BRUNSWICK-GLYNN COUNTY JOINT WATER & SEWER COMMISSION

PROJECT: Request for Proposal No. 20-028 – Advanced Metering Infrastructure and Meter Data Management System for the BGJWSC

ADDENDUM: Three (3)

**IRRIGATION METER WITH BACKFLOW
PREVENTOR DETAIL**

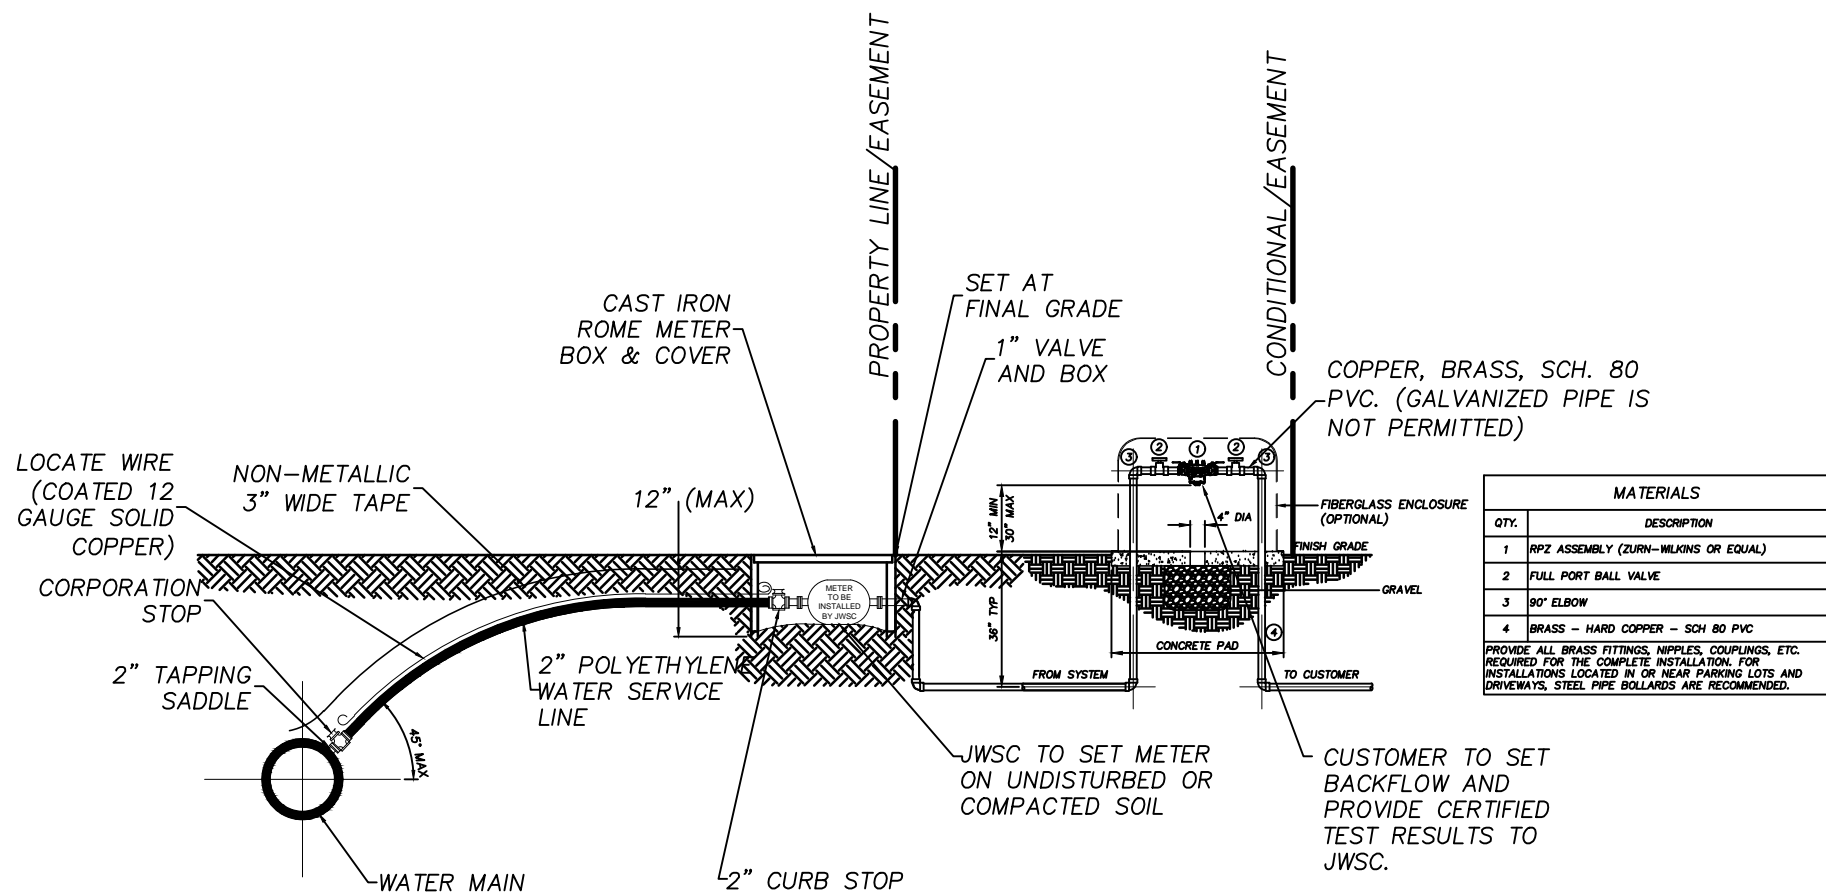
6) QUESTION: Are there large meters with strainers? If so, could JWSC please provide the specs?

10) QUESTION: Will specs for vaults be released?

73) QUESTION: For large meters 3" and above, are there drawings/pictures of these settings? Will the Contractor be required to make modifications to these settings, provide material, etc?

ANSWER: Please see attached Construction Details.

ANSWER: Please see attached Construction Details.

ANSWER: Please see attached Construction Standards.

SINGLE WATER SERVICE DETAIL

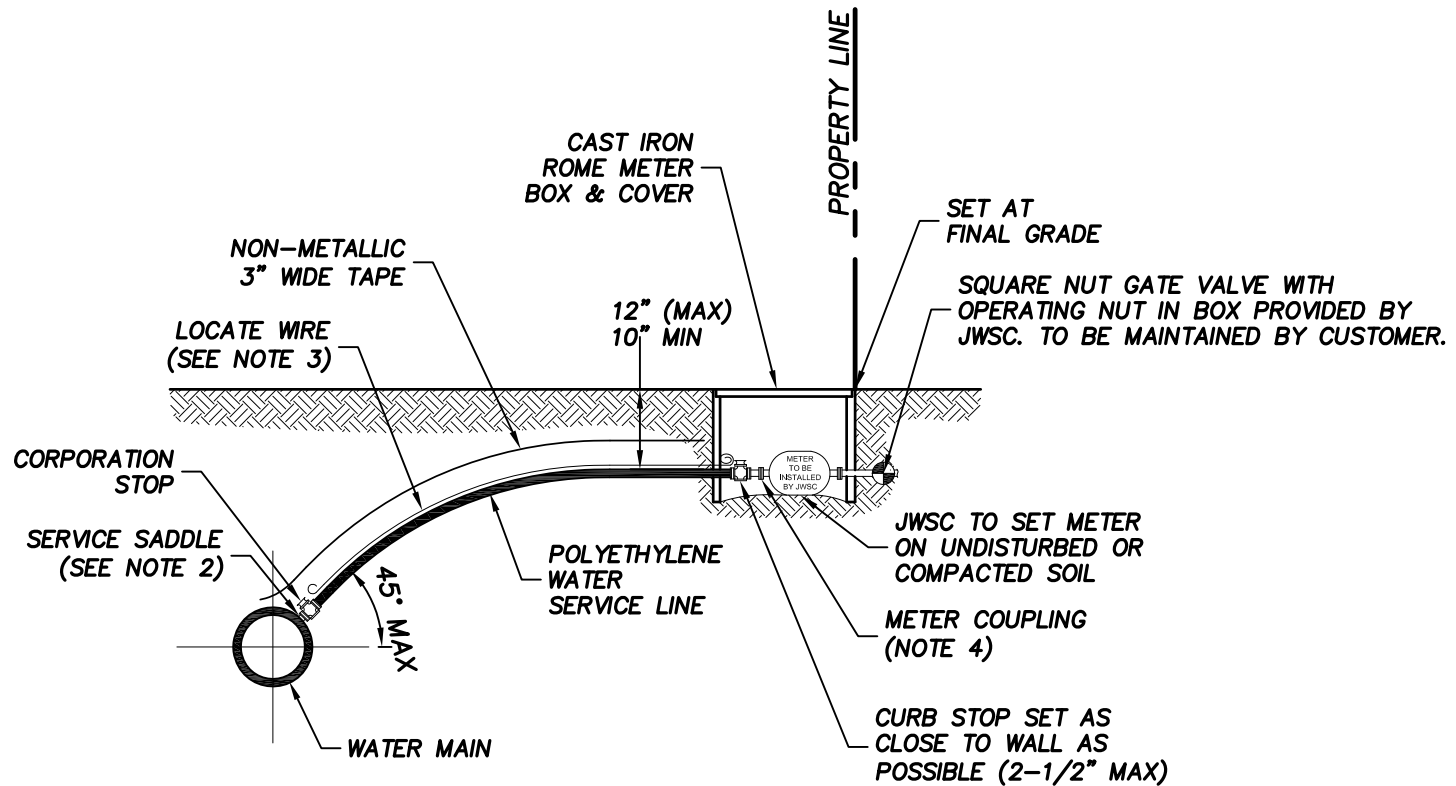
5) QUESTION: What is the pricing/installation process? Are there specific boxes? Should they be replaced like for like (curb stop, backflow)

36) QUESTION: A project of this scope and size should have a detailed site survey with drawings on the typical meter site for each type and size of meter conducted on all meter locations. When will this be available to the proposers?

ANSWER: Please see attached Construction Details

ANSWER: Please see attached Construction Details.
